**SECTION 00 90 01  
BIDDING AND CONTRACT REQUIREMENTS  
ADDENDUM NUMBER (1)**

Issued: October 17, 2018

**Re: ADDENDUM NUMBER (1) TO THE BIDDING DOCUMENTS FOR**

**McHenry County College  
Buildings A & E Renovations – BP2  
Architect's Project Number: 18-001**

**E1.21**

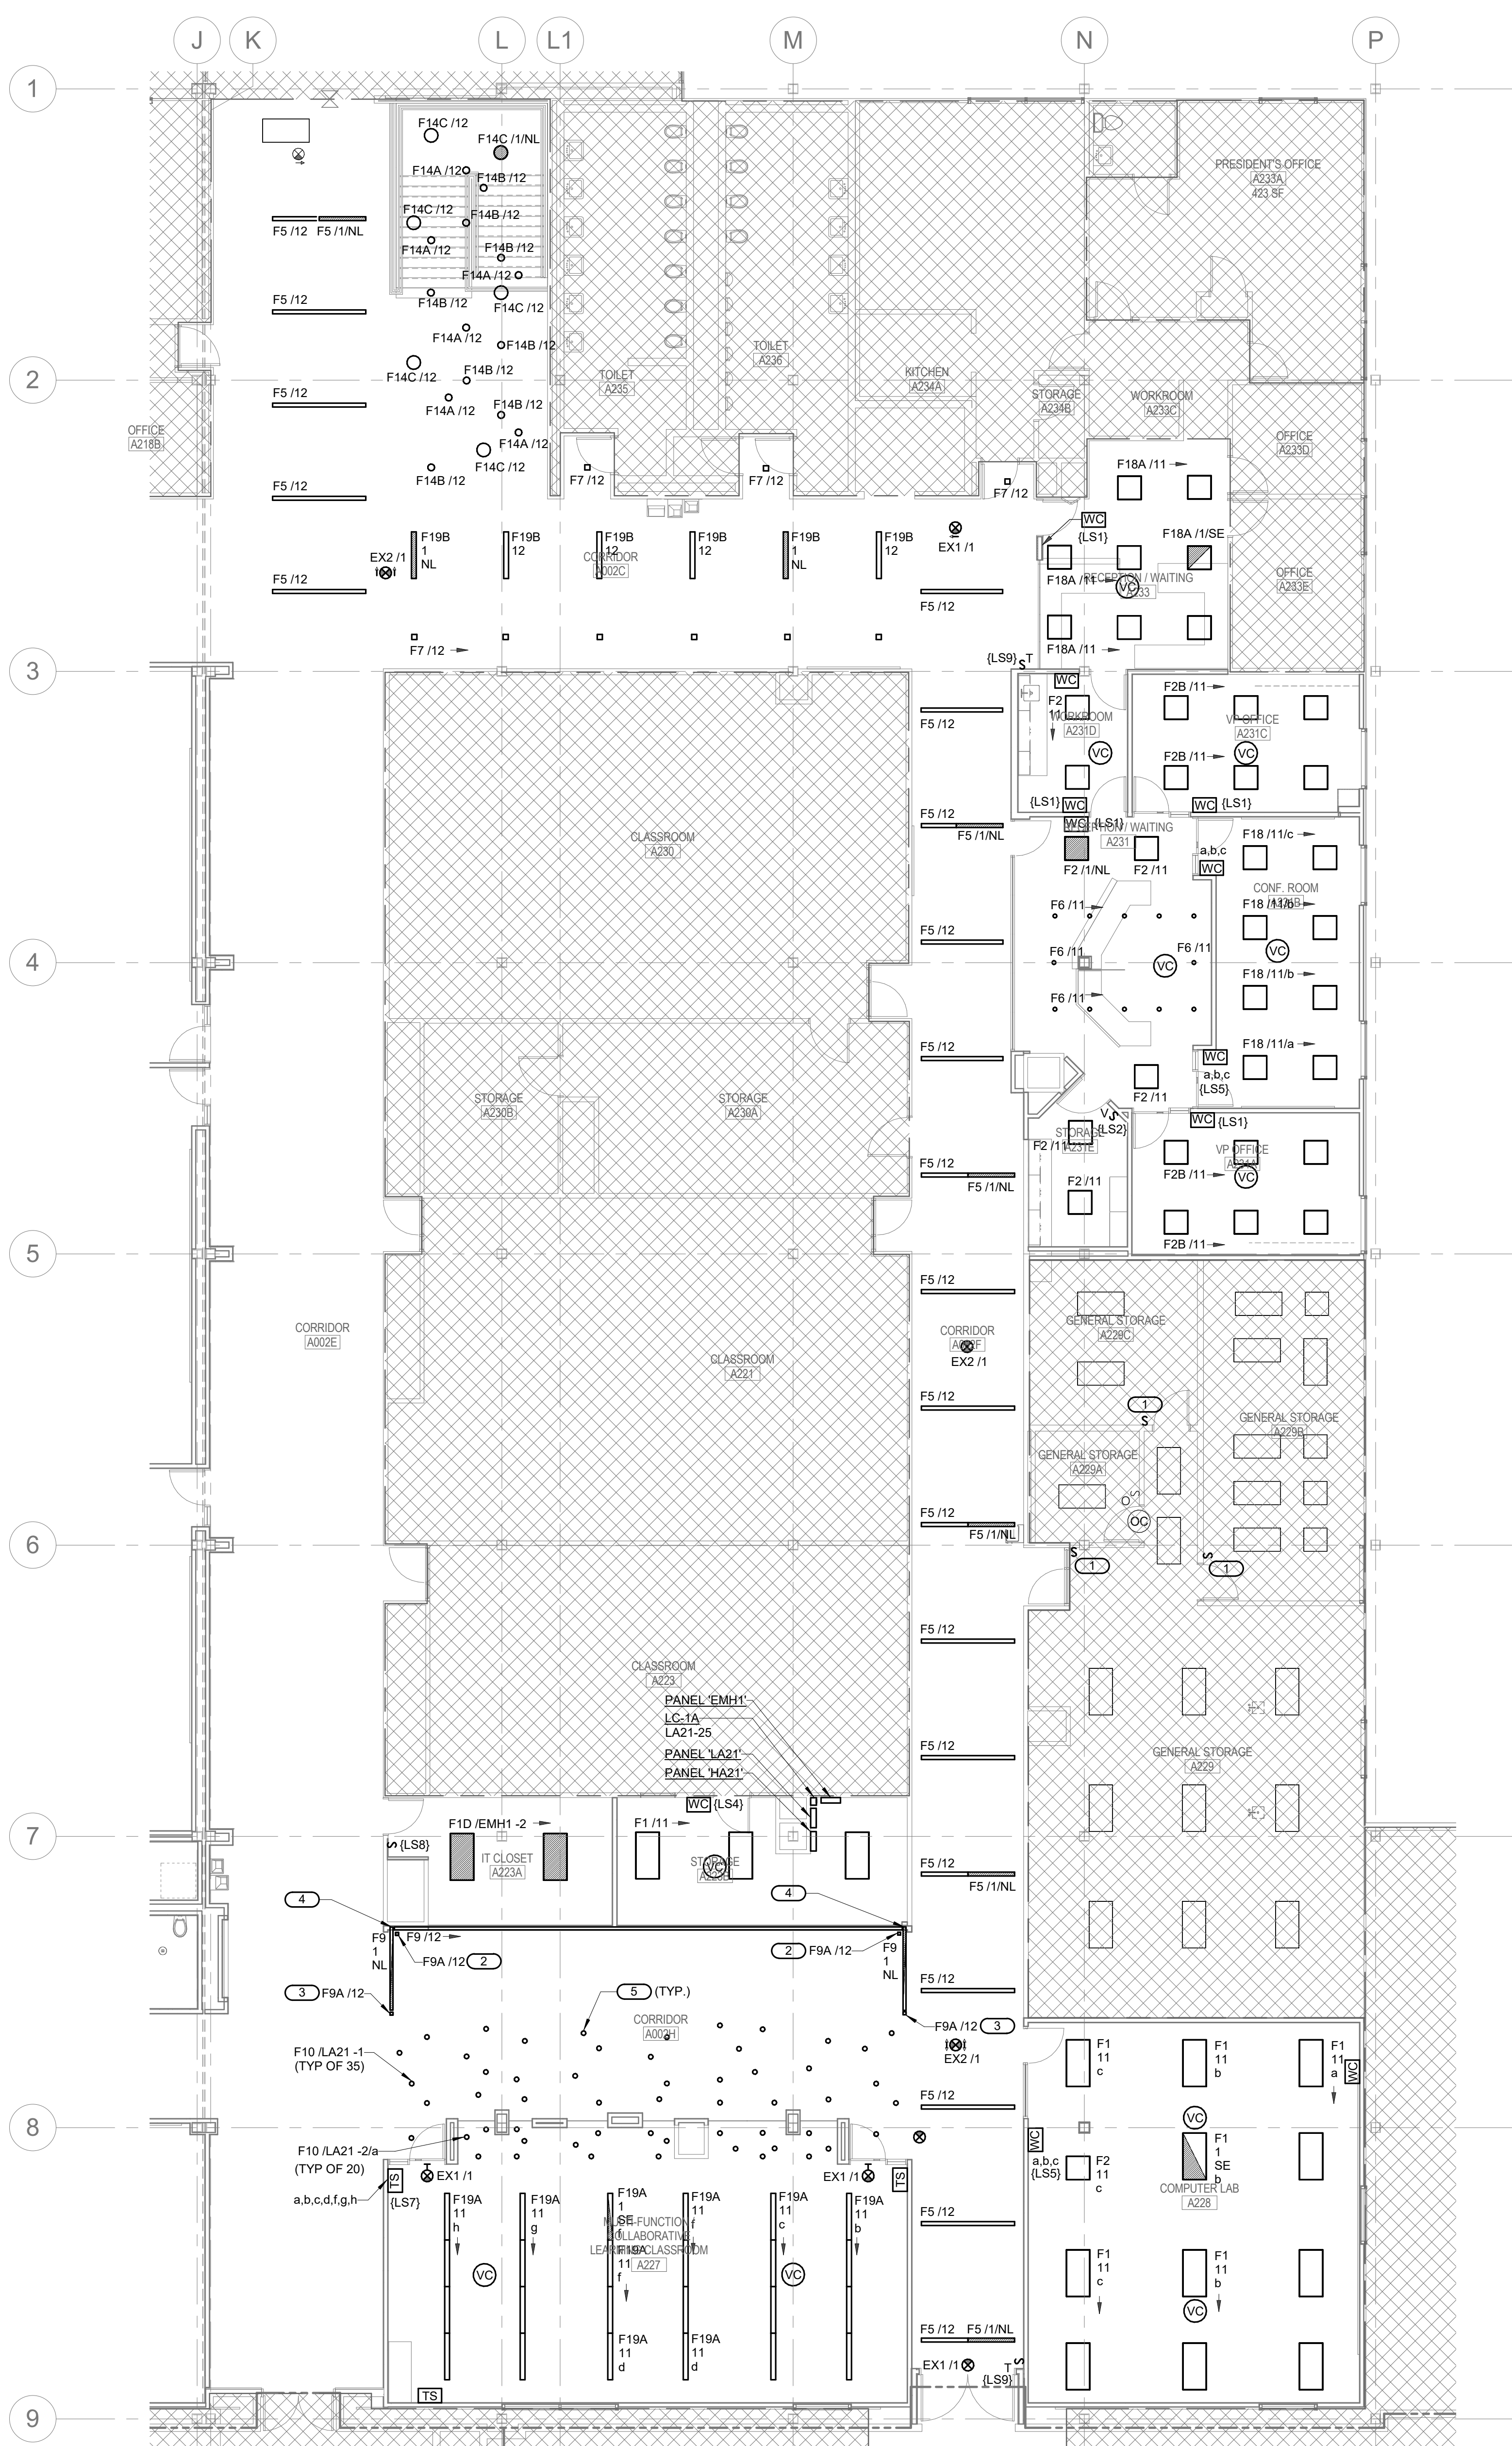
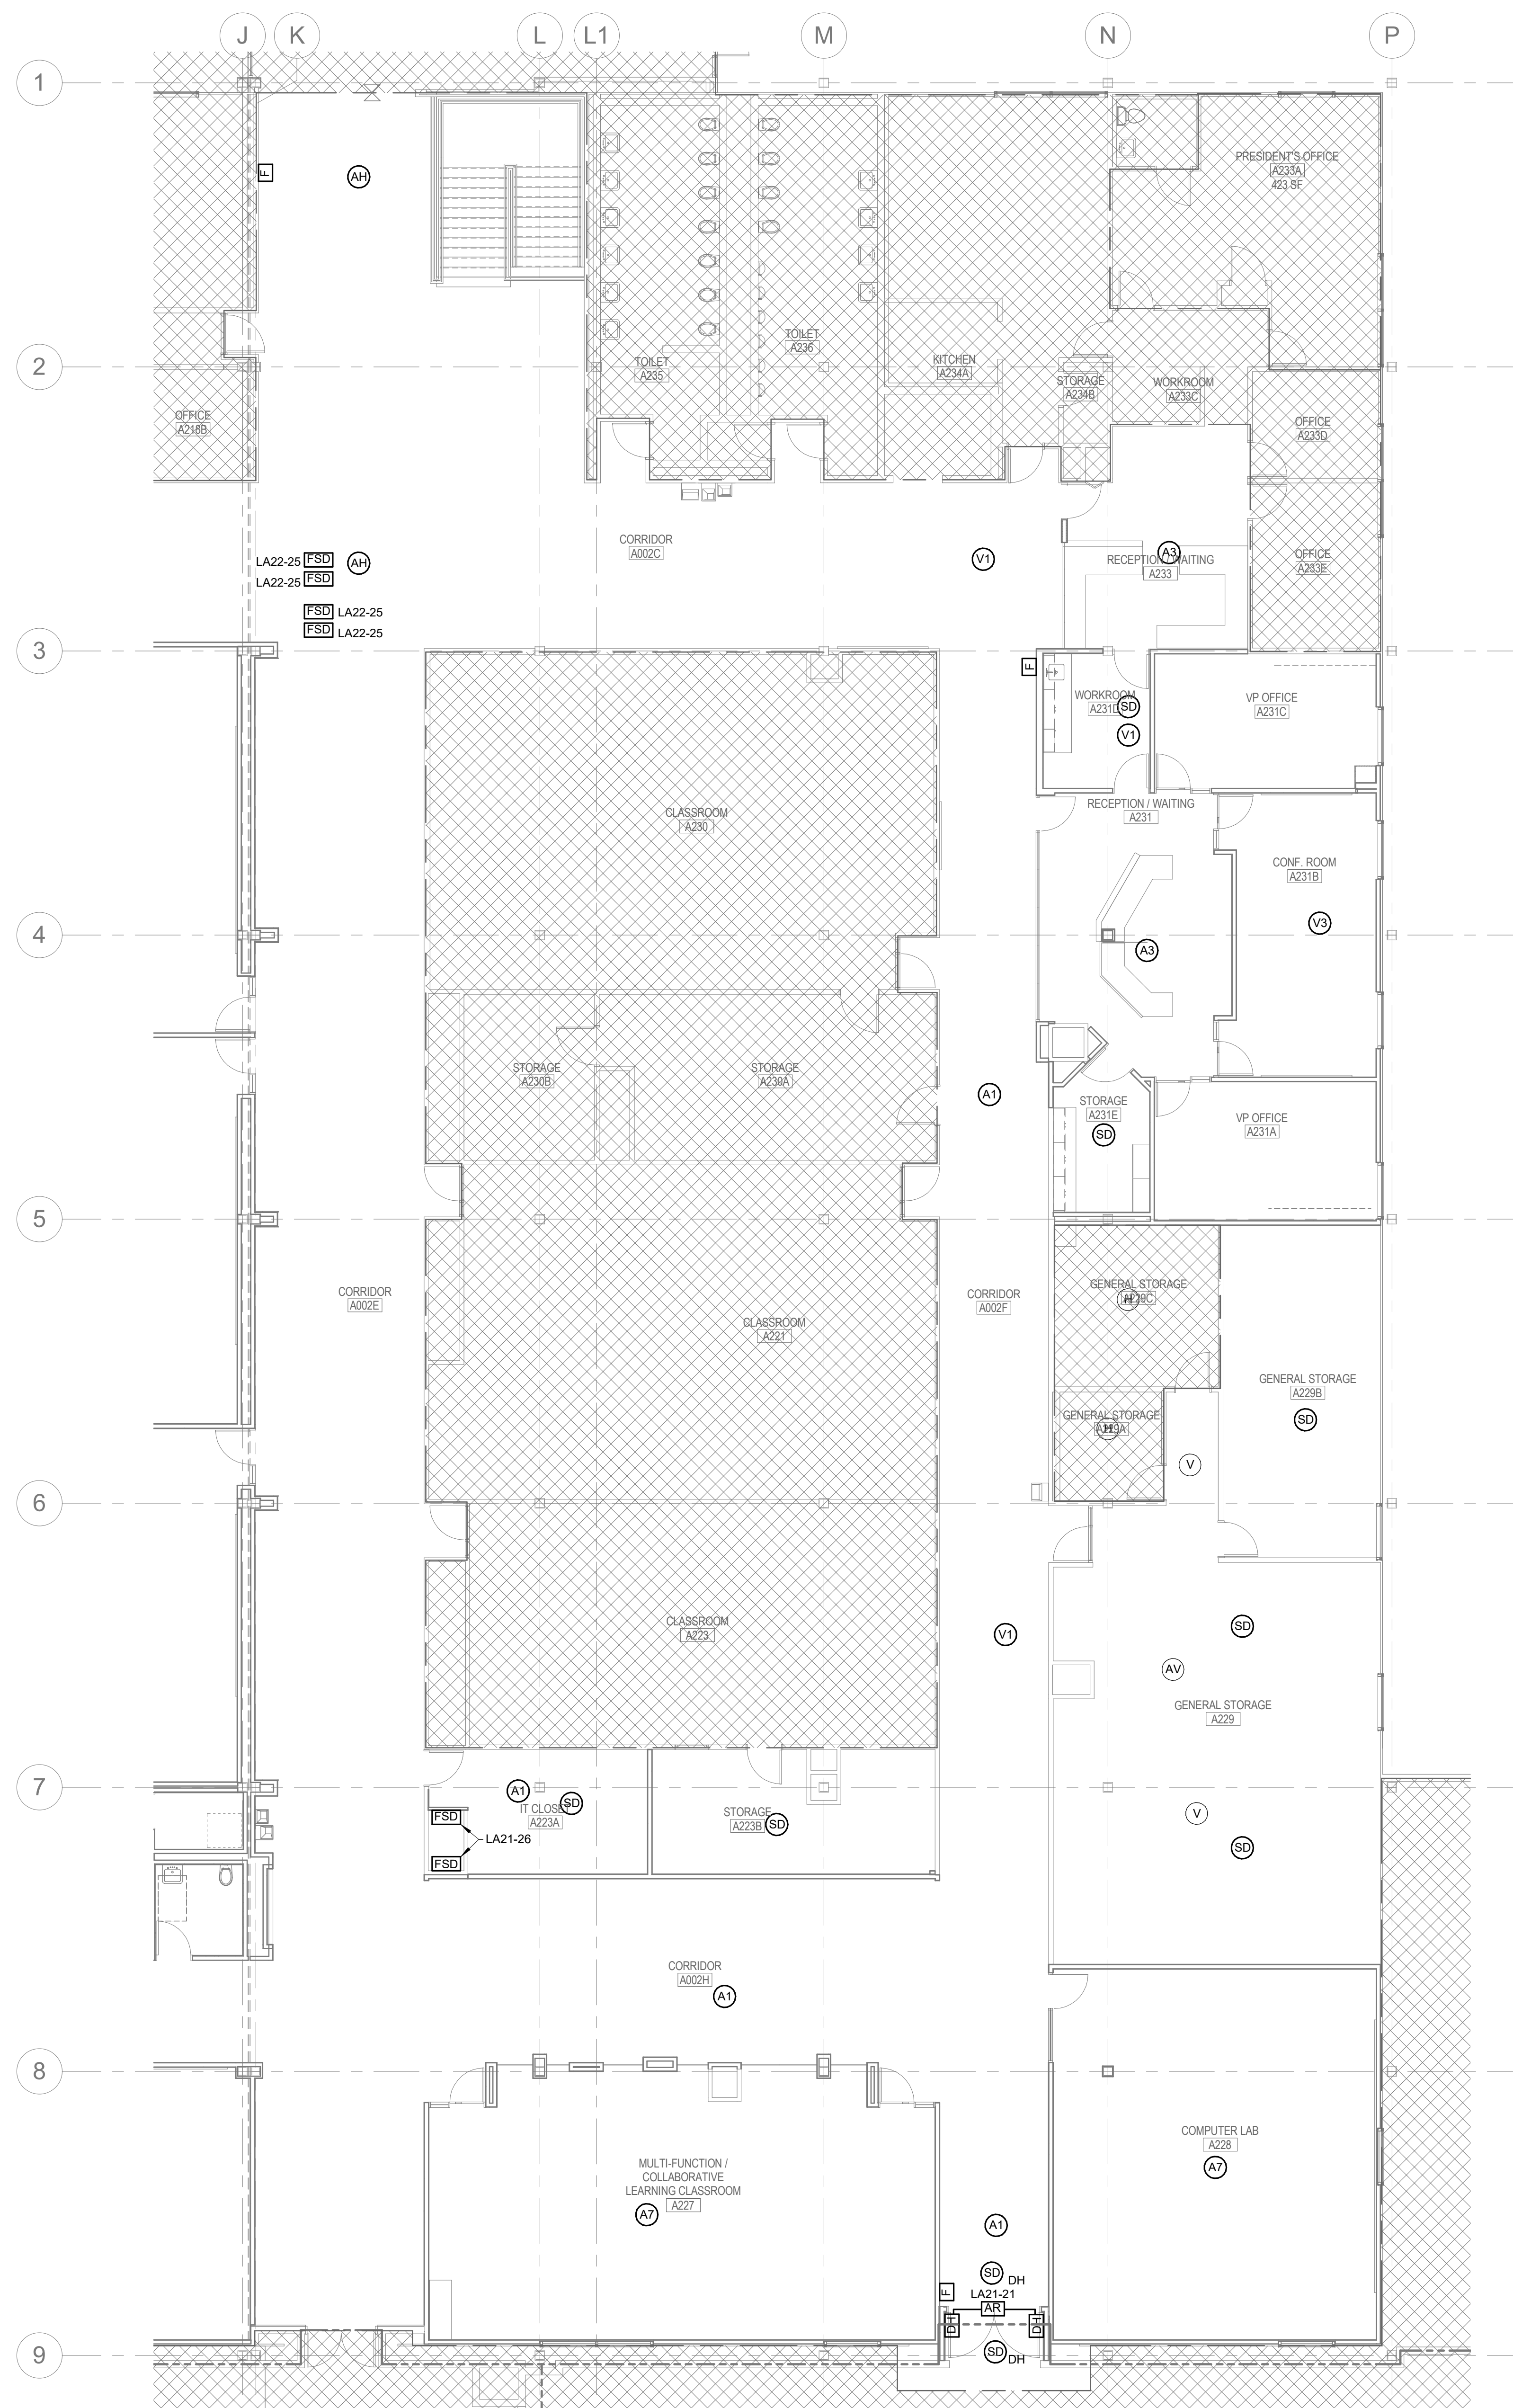
1. ED1.21
  - A. **REVISE** scope of work as shown in enlarged plans 2/ED1.21 and 3/ED1.21.
  - B. **REVISE** keynotes as shown.
2. E1.10
  - A. **REVISE** plan reference tags as shown.
3. E1.21
  - A. **ADD** keynote #8 in enlarged plans 2/E1.21 and 3/E1.21.
  - B. **REVISE** keynotes as shown.
4. E3.21
  - A. **ADD** work scope as shown in enlarged plans 2/E3.21 and 3/E3.21.
  - B. **REVISE** keynotes as shown.
